Change to Product Bulletin No. 2 of 2003 Oct. 27, 2003

Subject: Product Change to Part #550-039 Alignment Sleeve

Products Affected: Kirby Morgan SuperLite-17A/B & U.S. Navy MK-21 Mod. O & Mod. I Helmets

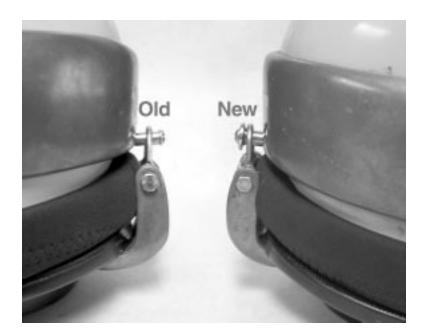
Beginning in November, 2003, all SuperLite 17A/B and MK-21 Helmets will come equipped with a new style Alignment Sleeve. The new part, Part #550-339, has a flange on its outer end which will help to insure that the Rear Hinge Tab Loop cannot become dislodged from its correct position over the Alignment Sleeve. The old style straight sleeve, Part # 550-039 is discontinued and no longer available.

This new part is retrofitable on all older SuperLite 17A/B & MK-21 Helmets. See your local Authorized KMDSI Dealer for price and delivery information.
